12 de junio de 2024

Asunto: Respuesta a la revisión de LEA sobre la actualización semanal del Plan de Monitoreo de Temperatura para la Medida de Mitigación #1B en el Vertedero de Chiquita Canyon, Castaic, California

Subject: Monthly Reaction Committee Determination on Reaction Area Boundary
Chiquita Canyon Landfill – Castaic, California

Attachment A – Reaction Area Map

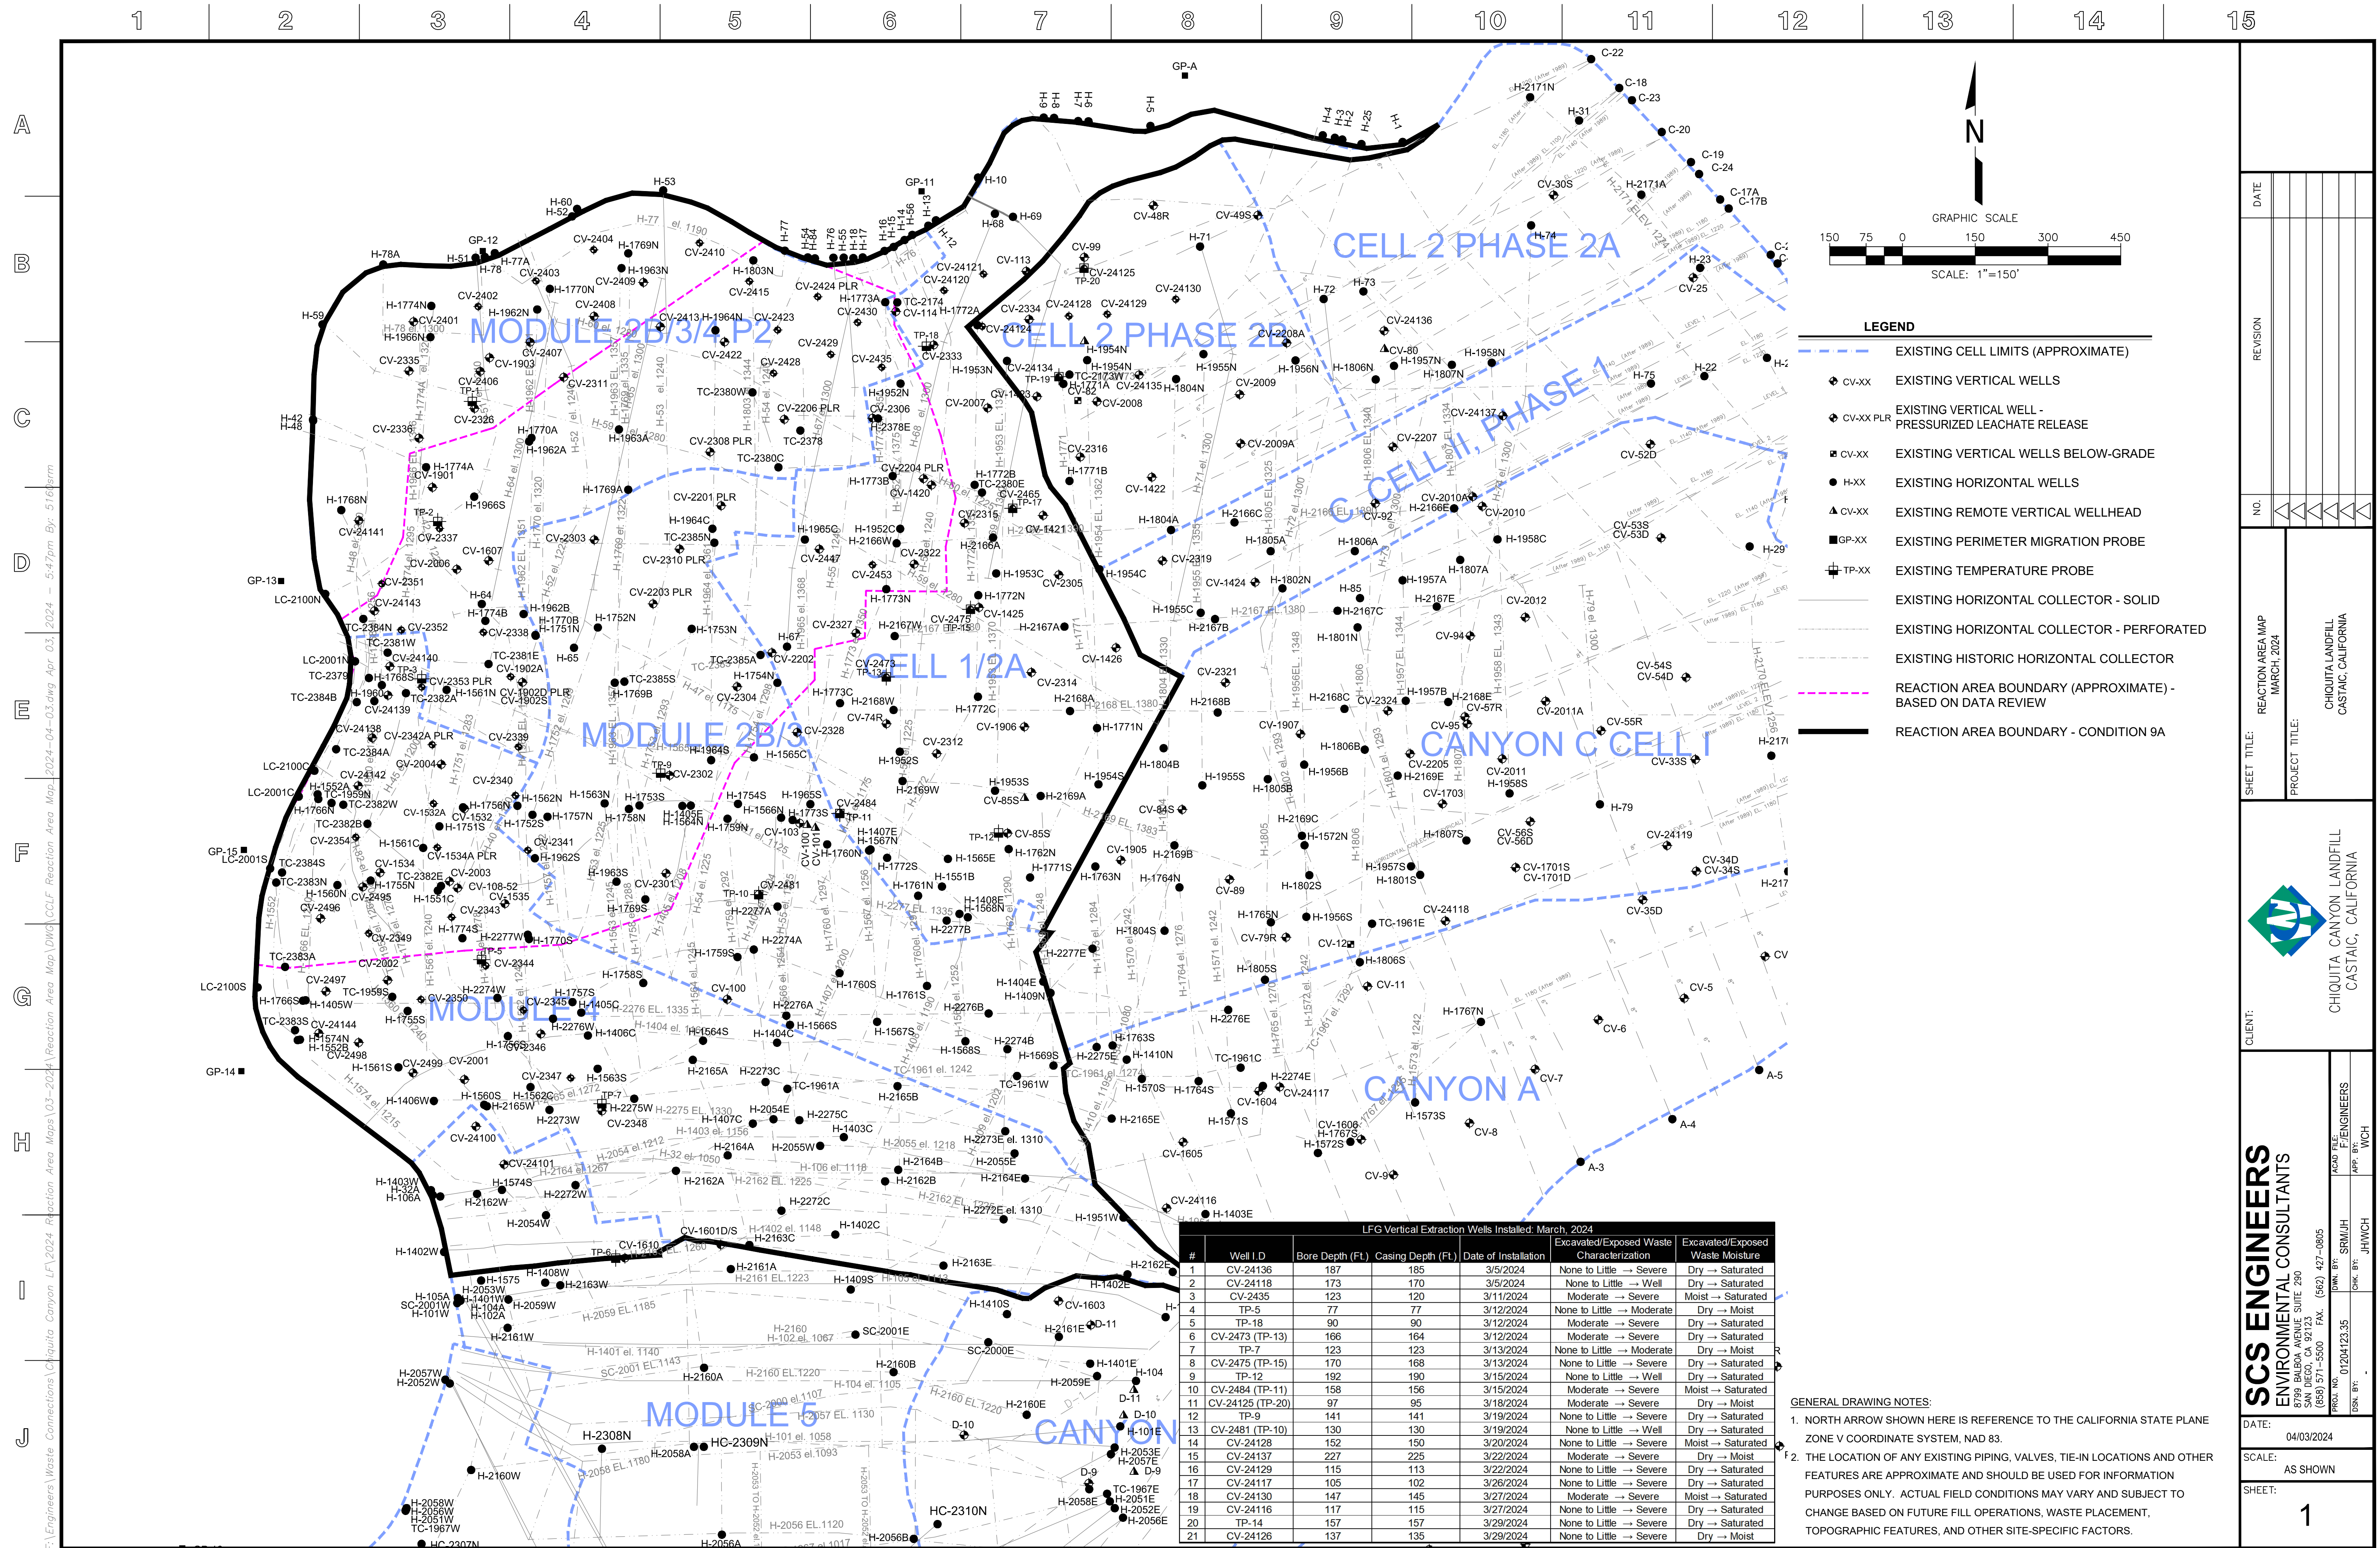
Attachment A presents the Drawing, titled “Reaction Area Map”, prepared by SCS Engineers (SCS) and dated 4/3/24. The Drawing depicts the Reaction Area boundary as prescribed in Condition No. 9a, which corresponds to the limits of Cells 1/2A, 2B/3, 4, and Module 2B/3/4 P2 as a solid black line. The Drawing also depicts the estimated extent of ETLF conditions being experienced at the site based on the Reaction Committee’s review of scientific data as a dashed magenta line. As presented on the Drawing, the estimated extent of ETLF conditions (dashed magenta line) is fully contained within the Reaction Area boundary decreed in the SOFA (solid black line). Because the ETLF conditions are fully contained within the Reaction Area boundary and have not expanded into a new cell, the Reaction Committee finds no basis to modify the Reaction Area boundary at this time. Please note the following:

- The rationale serving as the basis for considering adjustments and modifications to the Reaction Area boundary (or the determination to maintain the decreed boundary), include:
 - Landfill gas (LFG) wellhead temperatures in excess of approximately 160 degrees Fahrenheit.
 - Poor gas quality (defined as methane levels of less than 30 percent) in conjunction with methane-to-carbon dioxide (CH₄:CO₂) ratios less than 1.0.
 - The concentration of hydrogen (H₂) in the LFG measured greater than 2 percent by volume.
 - Accelerated settlement of the landfill surface, defined as approximately 6 inches or greater within a 60-day period, and cracks in landfill cover.

SHEET TITLE:	REACTION AREA MAP APRIL, 2024
PROJECT TITLE:	CHIQUITA CANYON LANDFILL CASTAIC, CALIFORNIA

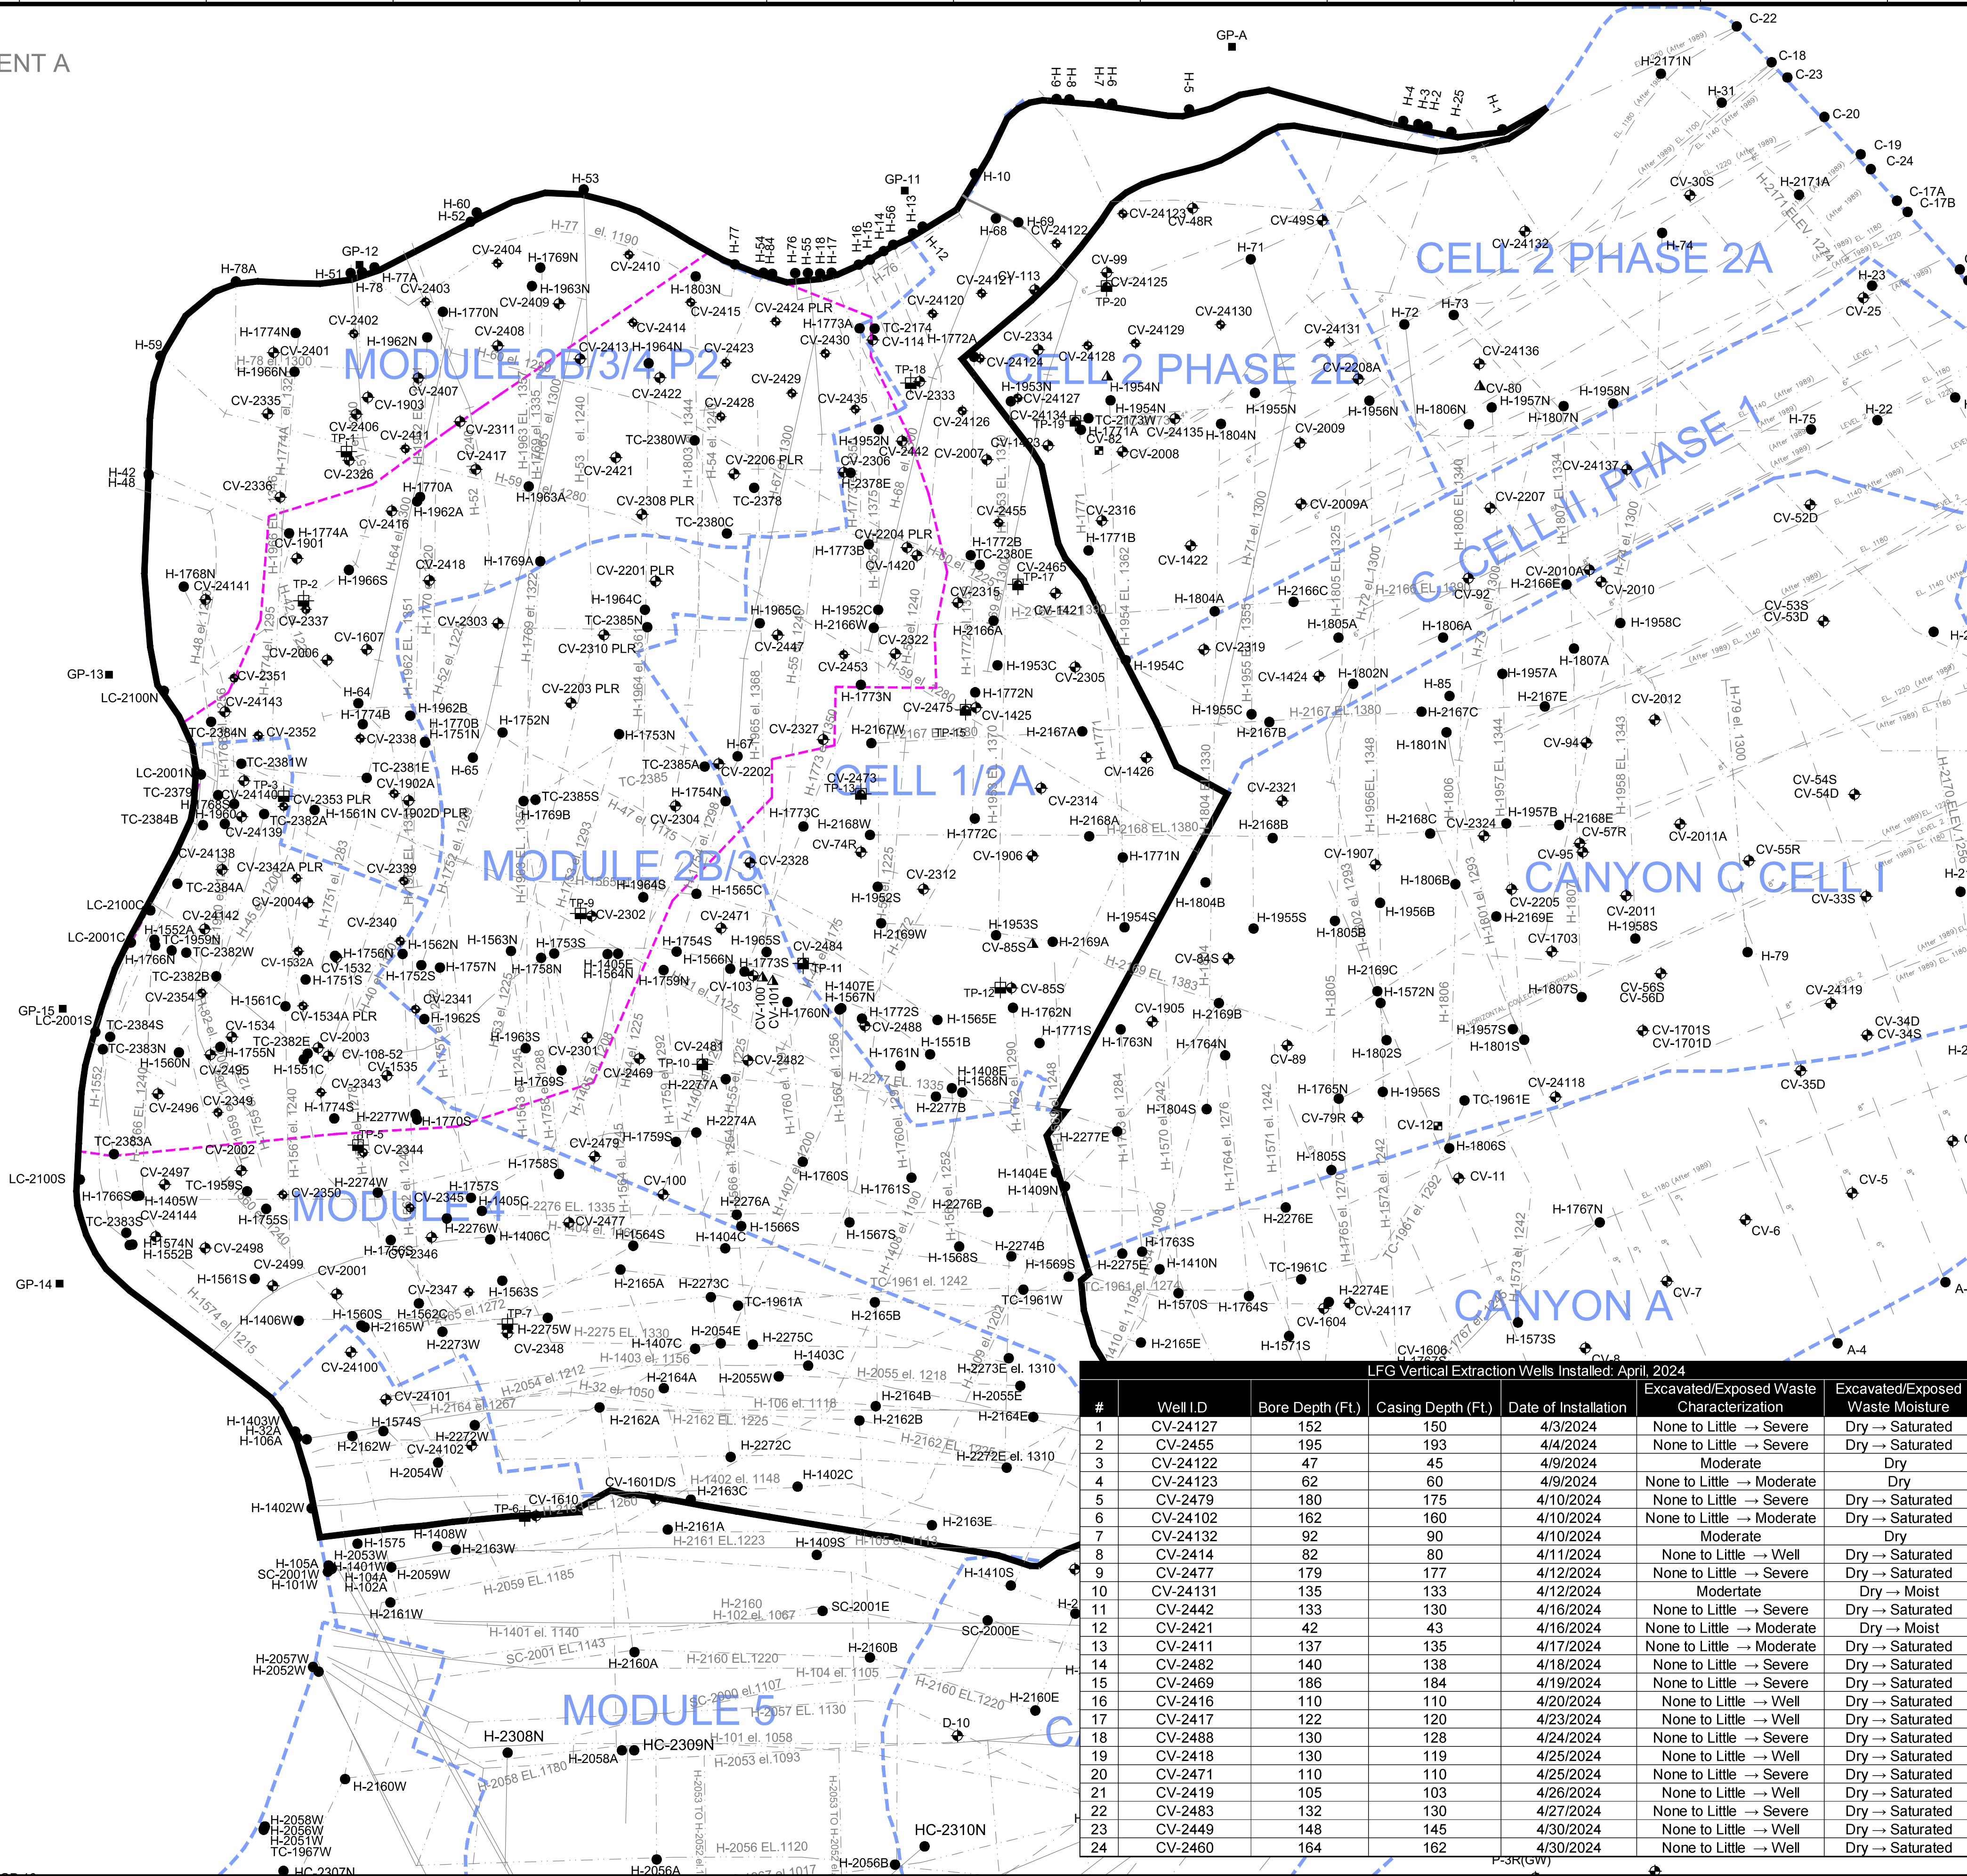
Attachment A presents the Drawing, titled “Reaction Area Map”, prepared by SCS Engineers (SCS) and dated 5/6/24. The Drawing depicts the Reaction Area boundary as prescribed in Condition No. 9a, which corresponds to the limits of Cells 1/2A, 2B/3, 4, and Module 2B/3/4 P2, as a solid black line. The Drawing also depicts the estimated extent of ETLF conditions being experienced at the site based on the Reaction Committee’s review of scientific data as a dashed magenta line.

The Reaction Committee also reviewed the limited initial temperature measurements recorded by the newly installed temperature monitoring probes. Five (5) of the twenty (20) probes (TP-2, 3, 4, 9, and 16) are located within the estimated extent of ETLF conditions (dashed magenta line), and ten (10) probes are positioned adjacent to (within 200 feet) of this boundary. The initial temperatures recorded by the probes are relatively cooler compared to values recorded at other ETLF sites, and it is the Committee’s opinion that they do not substantiate a decision to expand the boundary of the reaction area at this time.

As presented on the Drawing included as **Attachment A**, the estimated extent of ETLF conditions (dashed magenta line) is fully contained within the Reaction Area boundary decreed in the SOFA (solid black line). Because the ETLF conditions are fully contained within the Reaction Area boundary and have not expanded into a new cell, the Reaction Committee finds no basis to modify the Reaction Area boundary at this time. Please note the following:
